**BOARD OF ZONING ADJUSTMENT  
STAFF REPORT****Date: August 1, 2016****CASE NUMBER**

6050

Spanish Villa Condominium Owners Association

**SETBACK:** Front Yard and Side Street Side Yard Setback Variances to allow masonry sign columns 7.3' high and masonry iron fence columns 7' high setback 2 inches from the front and side street property lines at a residential condominium complex in a R-3, Multi-Family Residential District.

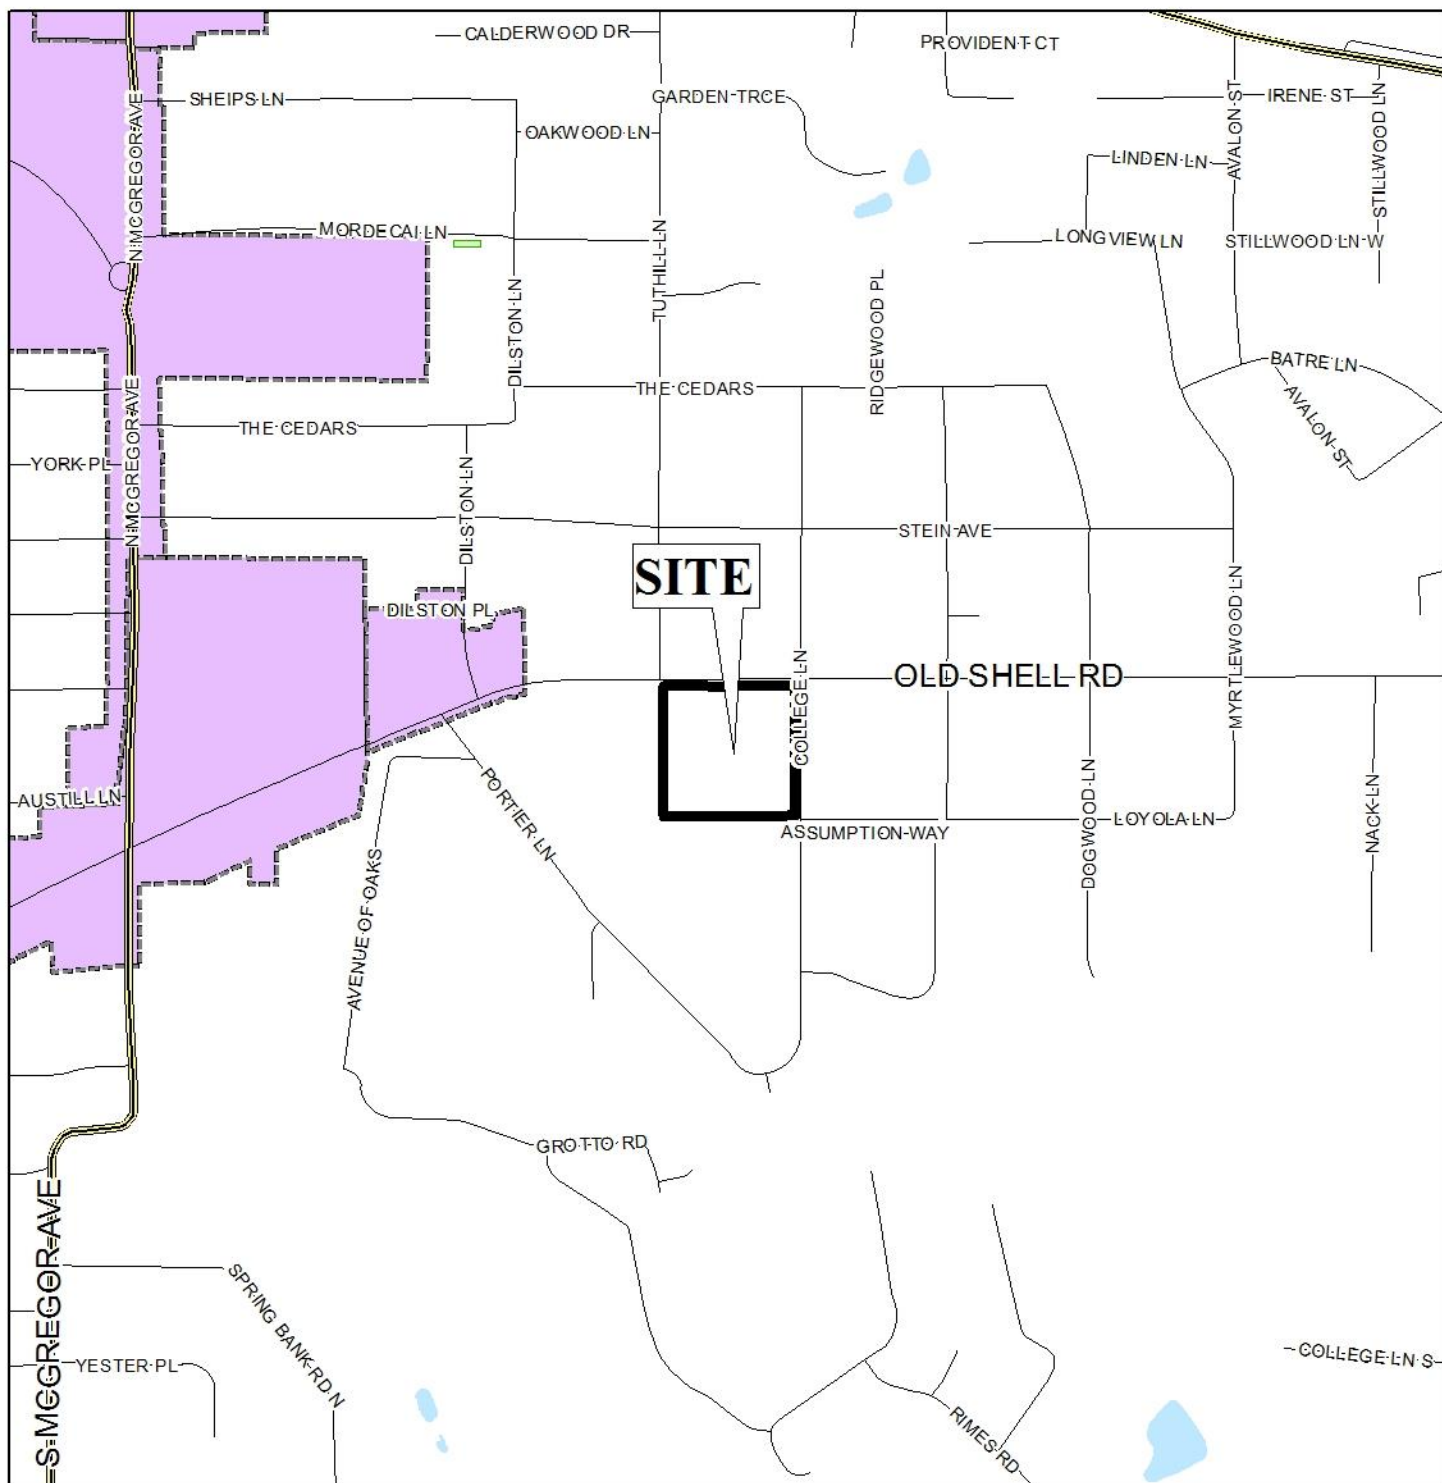
The location of the fence near the western driveway appears to create a line of sight issue for vehicles exiting the property. Although the rod iron fence is not a solid fence, it can have the appearance as such when viewed at an angle. There is also a 36" oak tree that further limits the line of sight. This issue could be eliminated by setting the fence further on to private property. Also, as illustrated, all the parking stalls on the west aisle will need to be restriped to illustrate angled parking northbound.

In accordance with the IFC 2012 Sections 503.2.1, 503.4, 503.6, D103.5. Fire Apparatus access roads shall have an unobstructed width of not less than 20 feet. The Fire Code official can allow the installation of security gates as long as they do not violate the Fire Code requirements above. Nothing shall impede the 20 foot width requirement.

The site plan depicts the proposed two-way entrance gate as having a 24' wide driveway with a key pad. The Fire Department requires a clear width of 20' for a drive isle to accommodate fire trucks. Also, a Fire Apparatus access road shall have an unobstructed width of not less than 20 feet and nothing is allowed to impede the 20' width requirement. It appears that the current location of the proposed key pad would interfere with the clearance required by the 2012 International Fire Code. The site plan should be revised to reflect fire requirements.

The two-way entrance is depicted as retaining the two split curb-cuts. It is recommended that the curb-cut be rebuilt to a standard 24' wide curb-cut.

The site plan also depicts 20' wide exit only driveway. Based on the proposed layout, one of the existing curb-cuts associated with the exit-only gate must be removed. The site plan should be revised to depict those changes.

- 1) revision of the site plan to depict the fence and exit gate with a 10' setback along Old Shell Road frontage;
- 2) revision of the site plan reflect Fire Department requirements per the 2012 International Fire Code; and
- 3) revision the site plan to depict a single 20' wide curb-cut for the exit-only driveway, and a single 24' wide curb-cut for the two-way driveway.
